General Comments

2.1 Procedure

Figure. 1. Uncertainty concept in this study

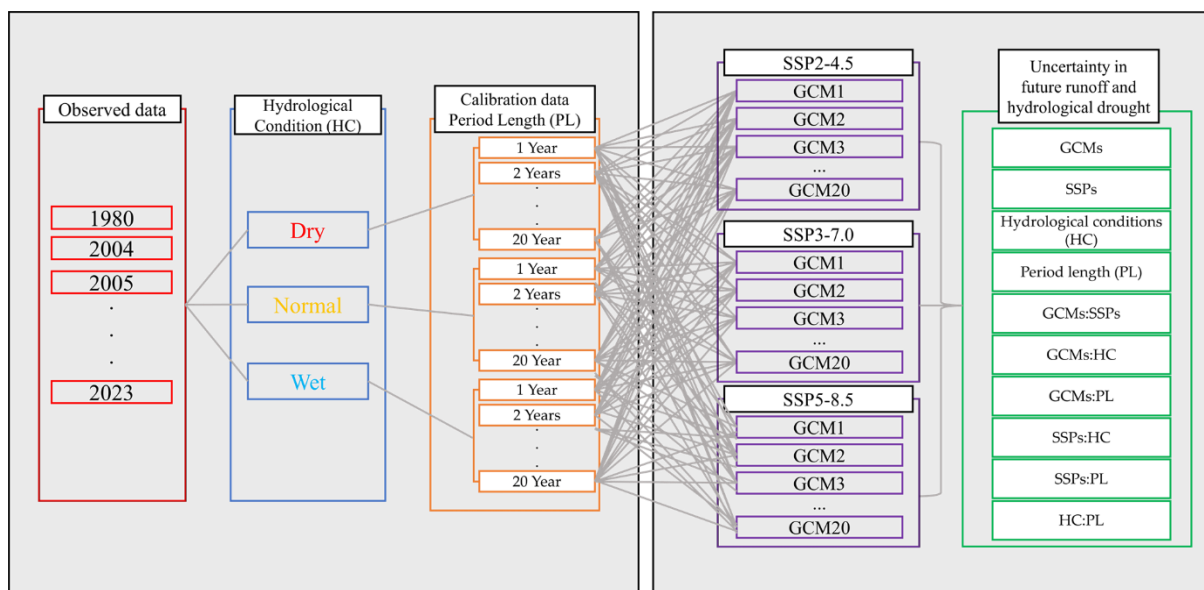
The methodology is valid but quite complex and not always straightforward. An overview plot or flowchart would help clarify how the different simulations are organized and how the combination of GCMs, SSPs, calibration periods, hydrological conditions, and parameter sets is applied. Figures and tables are informative but must be clarified (more extensive captions and axis labels). Overall, this is a strong and complex manuscript with interesting results. Minor clarifications regarding methodology, figure/table captions, and interpretation of results would further strengthen the clarity.

Thank you for these excellent suggestions. We agree that the multi-step methodology, involving several interacting uncertainty drivers (GCM, SSP, HC, PL), can be complex to follow. We also agree that several captions and labels needed more detail to improve clarity.

To address the methodological complexity, we have added a new comprehensive concept as Figure 1 in the manuscript. We have also revised Section 2.1 (Procedure) to explicitly refer to this new figure, which now serves as a visual guide to the steps described.

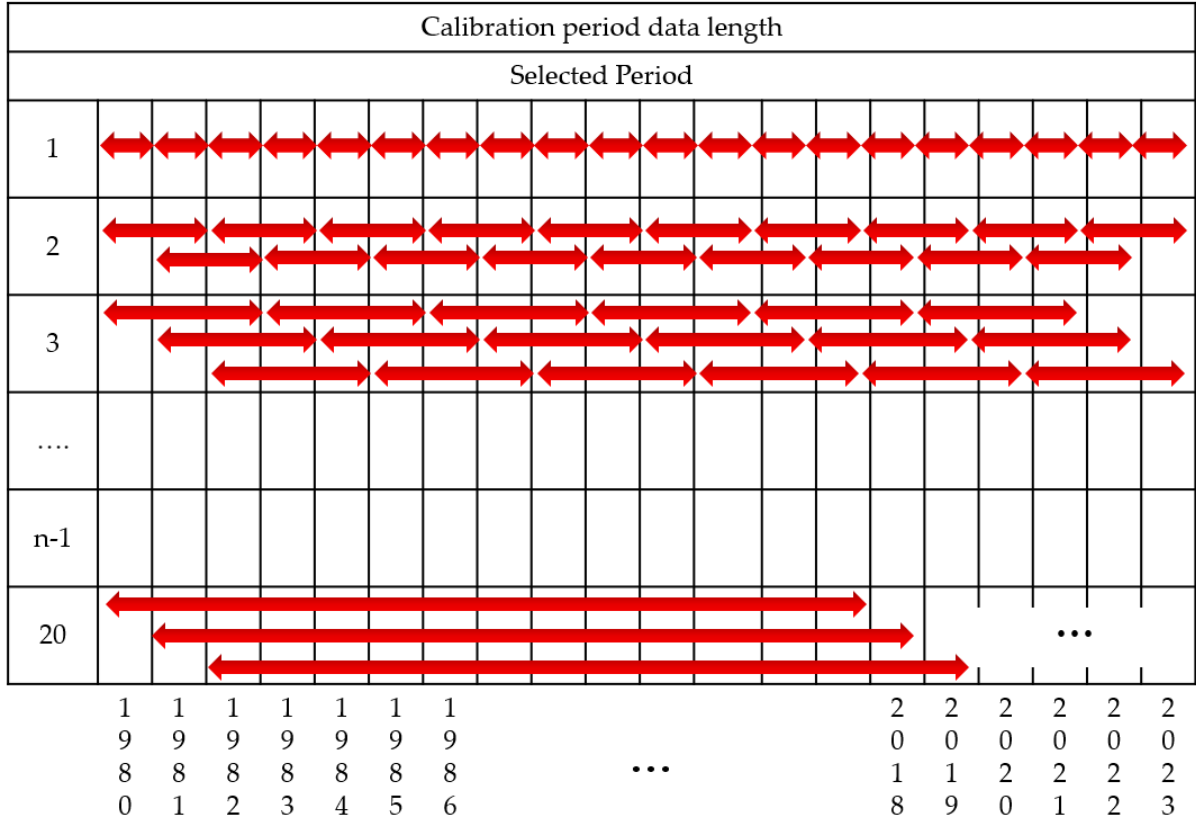
Figure S.2 helps, but the explanation remains unclear

Answer)
Thank you for this specific feedback. You are correct that the original caption for Figure S.2. Description of calibration period data lengths in this study was too brief and uninformative. We agree that this figure is important for understanding our experimental design for defining the Period Length (PL) uncertainty factor.

Figure. 3. Comparison of KGE values for the four basins using default parameters (Before) and calibrated parameters (After). The x-axis (1-20) represents the calibration data length, which defines the before calibration/after calibration data split.

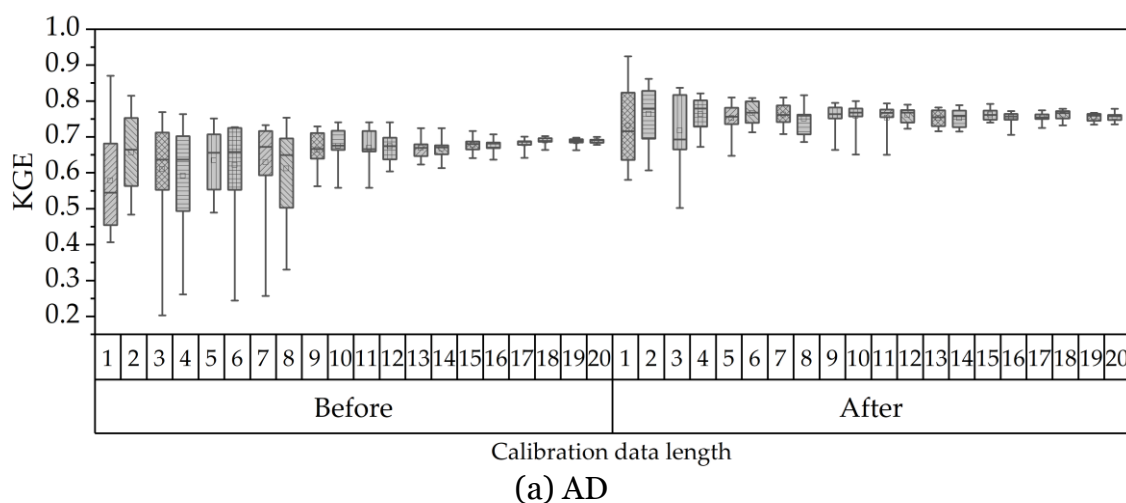
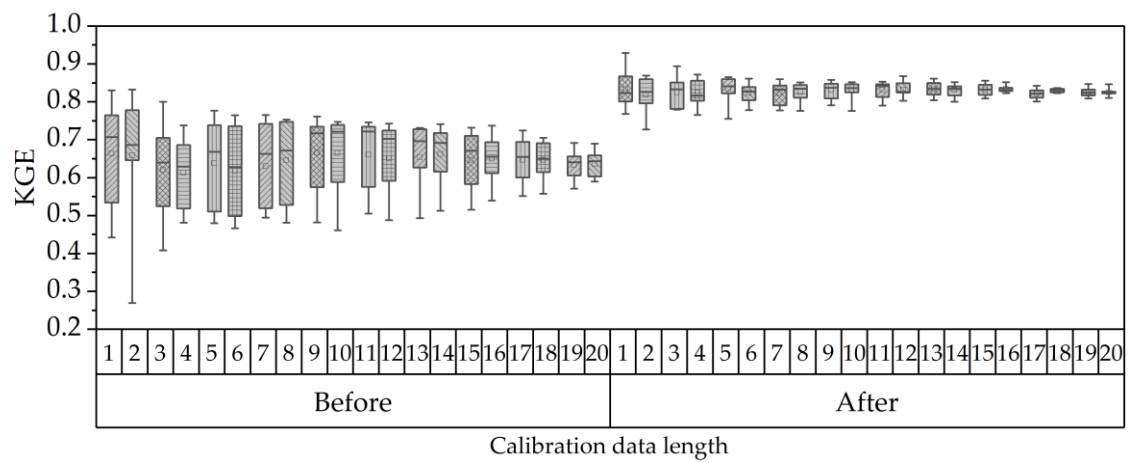
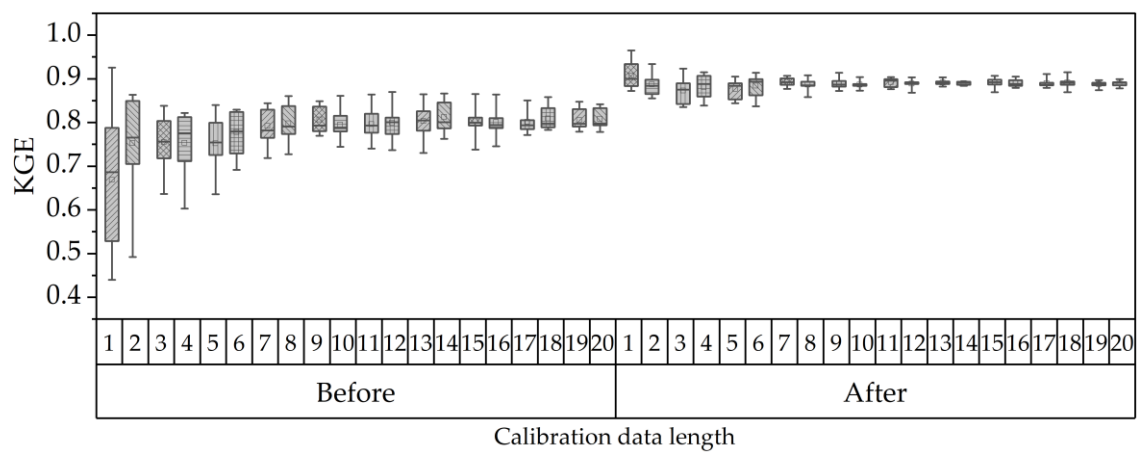
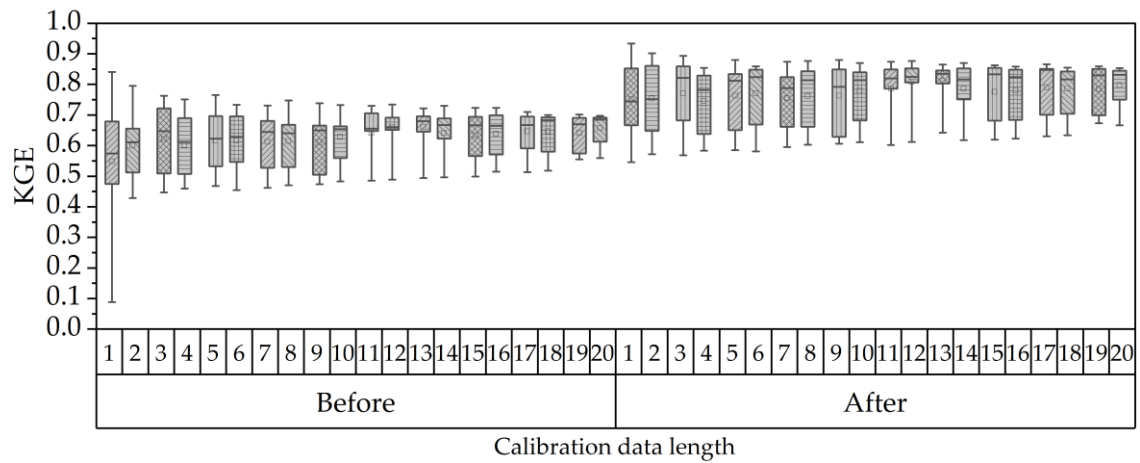
Figure 2: Boxplots over all model chains before and after calibration—clarify whether the x-axis representing “number of years for the calibration period” refers simply to the length of the modeling period for pre-calibration conditions. The meaning of the different structures in the boxplots could perhaps be simplified or clarified.

Thank you for this very specific and important question. You have identified a key point of confusion in this figure (which is now renumbered to Figure 3 in our revised manuscript). You are absolutely correct that the x-axis (1-20) in the 'Before' (pre-calibration) panel is confusing, and the original caption was too brief.

To clarify the figure's structure: The x-axis (1-20) defines the specific before calibration/after calibration data split. For any given x-axis value (e.g., '5'):

The 'After-5' boxplot shows the distribution of KGE values for the model calibrated on 5 years, evaluated on its corresponding calibration years.

The 'Before-5' boxplot shows the distribution of KGE values for the default, uncalibrated model, evaluated on the exact same validation years as the 'After-5' model.

This structure allows for a direct, fair comparison, demonstrating that the calibration process ('After') consistently outperforms the default model ('Before') when tested on the same data.

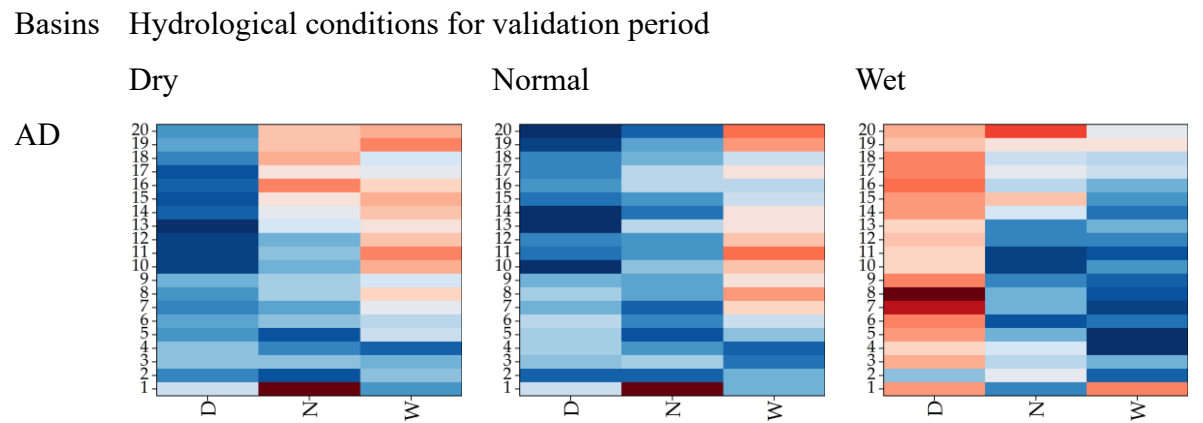
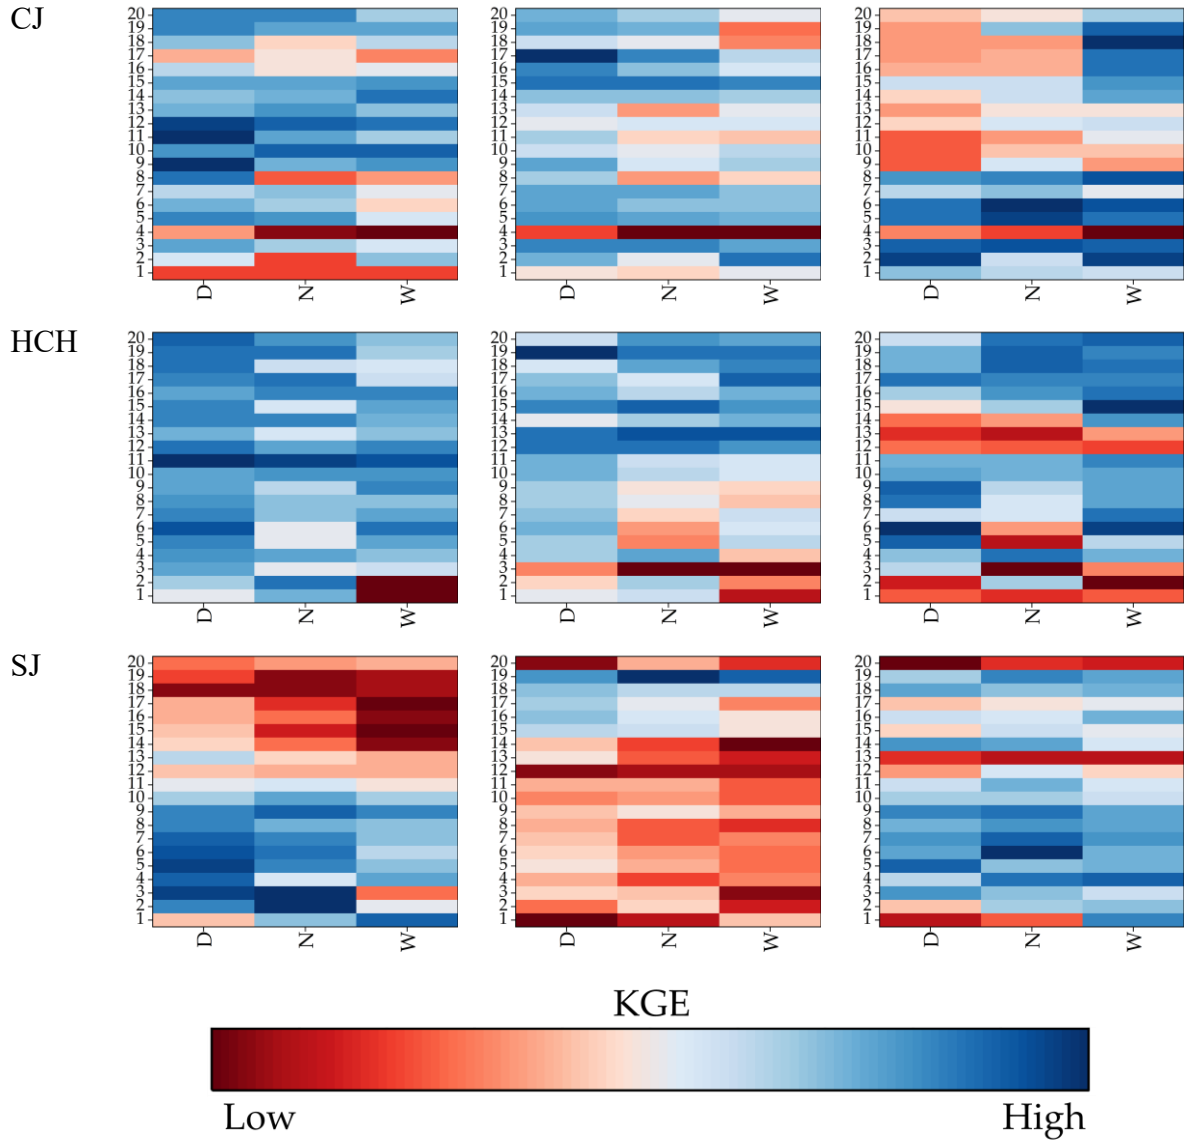
Figure 4: clearly indicate which wet (w), dry (d), and normal (n) conditions correspond to calibration and validation periods.

Thank you for this critical feedback. You are correct that the original caption for this complex figure (now numbered Figure 4) was insufficient and did not explain the figure's hierarchical structure, making it difficult to interpret.

We had already updated the color scheme (based on previous feedback) from the original to a more intuitive scale where Blue indicates high KGE (good performance) and Red indicates low KGE (poor performance).

Based on your specific suggestion, we have completely rewritten the caption for Figure 4. The new caption now explicitly details the structure: the main rows (Basins), the main columns (Validation Conditions), and, within each heatmap, the y-axis (Calibration Length) and x-axis (Calibration Conditions).

Figure. 8. Contribution of hydrological model parameters to the total uncertainty in the future 3-month SDI.

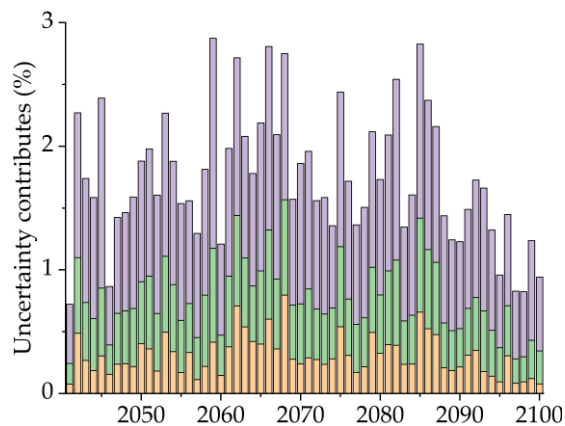
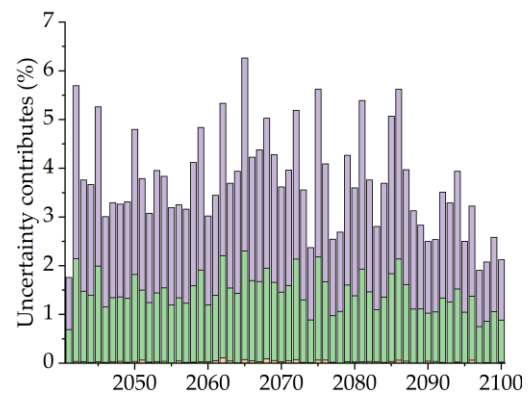
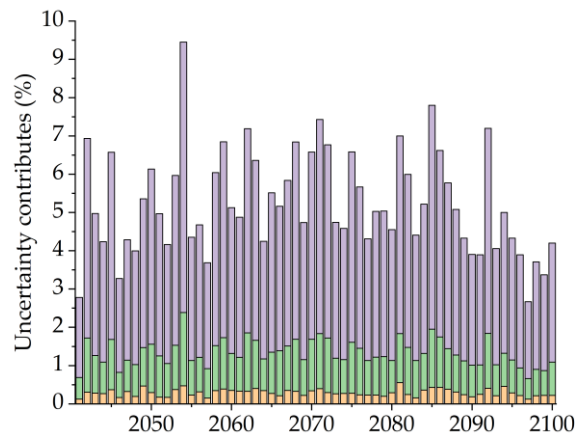
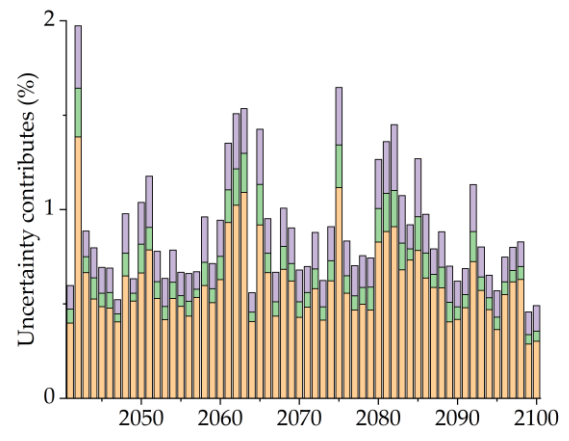
Figure 7: clarify what is being shown—number of drought events?

Thank you for this critical question, which identifies that the figure and its description were unclear. You are correct to question it; this figure (now renumbered to Figure 8) does not show the number of drought events.

Instead, it shows the percentage contribution (%) of the hydrological model factors (HC, PL, and their interaction) to the total uncertainty of the future 3-month SDI value (which is the standardized metric we use for hydrological drought analysis).

We have revised the text in Section 3.9.3 (specifically the sentence introducing Figure 8) to explicitly state that this figure shows the percentage contribution to the uncertainty of the 3-month SDI.

We have also rewritten the caption for Figure 8 to make this distinction clear.

Figure S. 1. Hydrological conditions defined by Streamflow Drought Index for the historical period

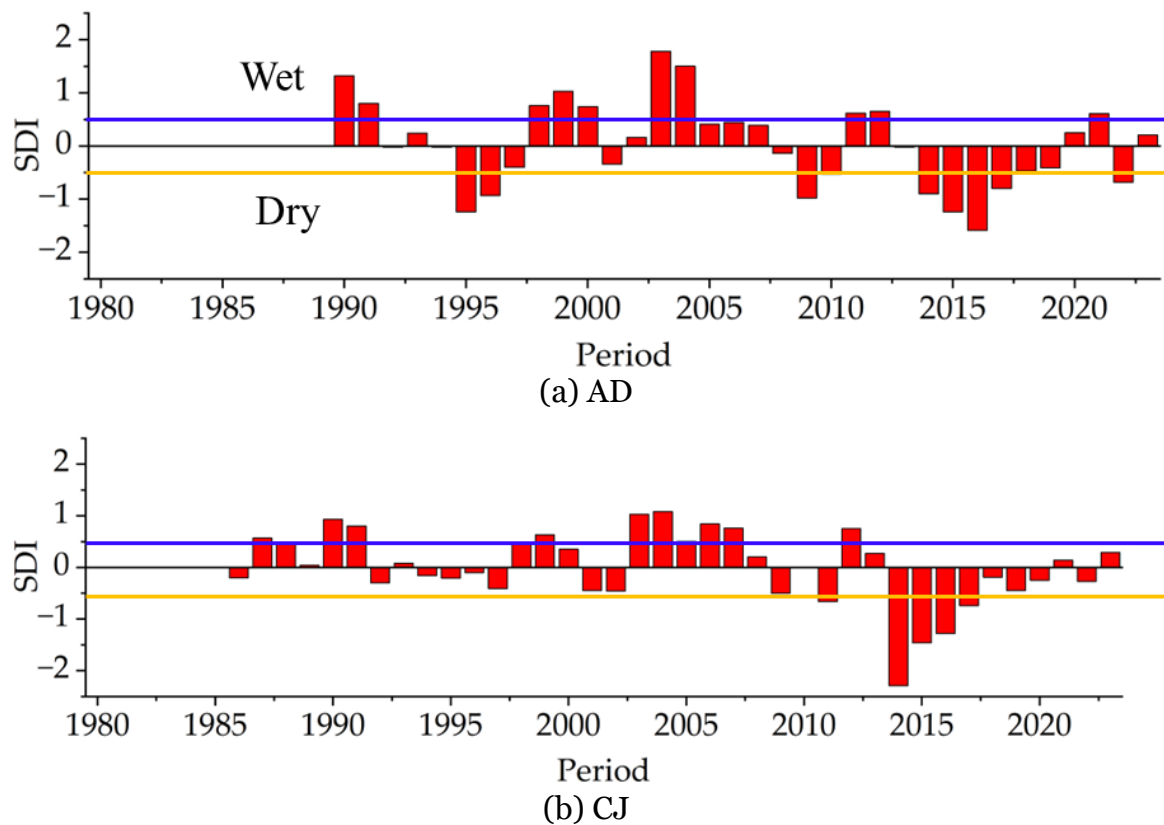
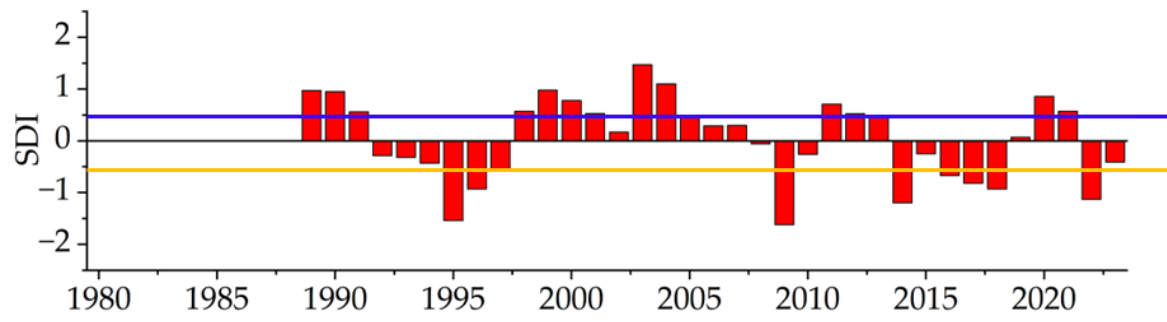
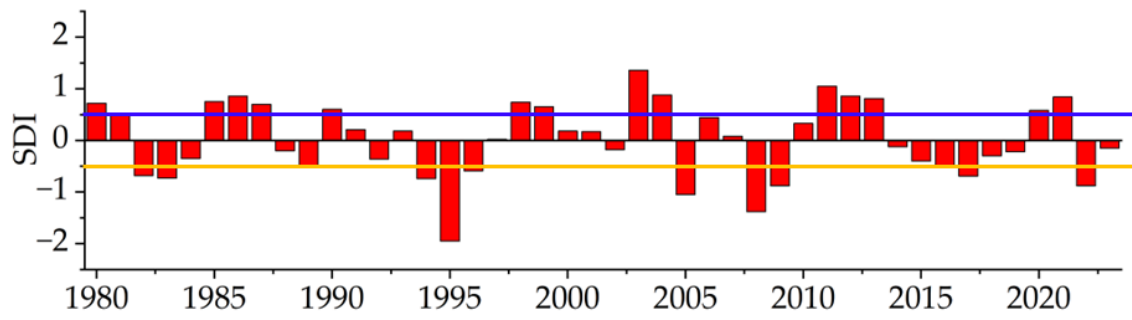
Figure S1: consider adding horizontal lines for the defined thresholds to indicate which condition each year would fall into.

This is a very helpful suggestion for improving the figure's readability. We agree completely. We have updated Figure S1 by adding two horizontal lines at the defined thresholds ($SDI = 0.5$ and $SDI = -0.5$) to clearly visualize the 'Dry', 'Normal', and 'Wet' categories, as recommended.
